Title and GS reference number of the project activity	Title: Production and sale of efficient cookstoves in the urban areas of Maputo Province GS reference no.: GS 11209		
Scale of the project activity	Large-scale <input checked="" type="checkbox"/> Small-scale <input type="checkbox"/> Micro-scale <input type="checkbox"/>		
Version number of the verification and certification report	3		
Completion date of the verification and certification report	03/01/2024		
Monitoring period number and duration of this monitoring period	2 nd (02/08/2021 to 01/08/2022)		
Version number of the monitoring report to which this report applies	3 of 29/12/2023		
Crediting period of the project activity corresponding to this monitoring period	1st Crediting Period; Start date – 02/08/2020. (02/08/2020 to 01/08/2025)		
Project participants (PP)	Carbonsink Group S.r.l (Carbonsink)		
Host Party	Mozambique		
Applied methodologies and standardized baselines	Technologies and Practices to Displace Decentralized Thermal Energy Consumption Version 3.1

The objective of this verification was to verify and certify emission reductions reported for the “Production and sale of efficient cookstoves in the urban areas of

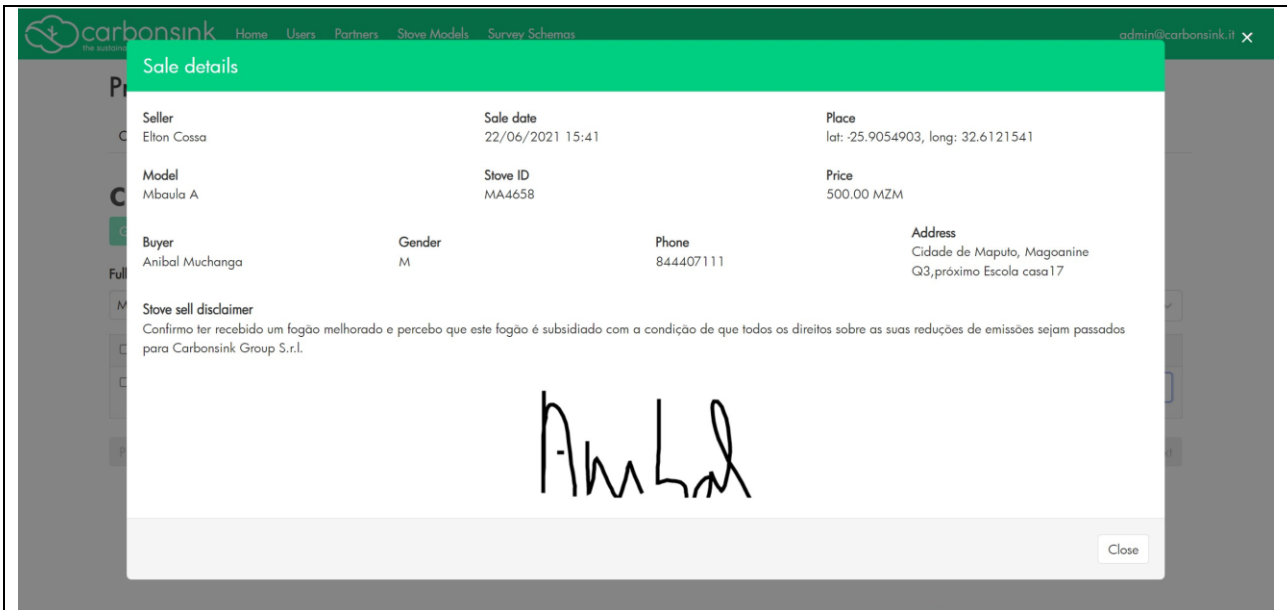
CAR ID	05	Section no.	Section C	Date: 30/09/2023
Description of CAR				
PP shall submit a sample of end user signed selling contract at the time of the stove purchase.				
Project participant response				Date: 04/10/2023
Please refer to the screenshot below and to the mentioned supporting documents (Selling Databases) for further cross-checks.
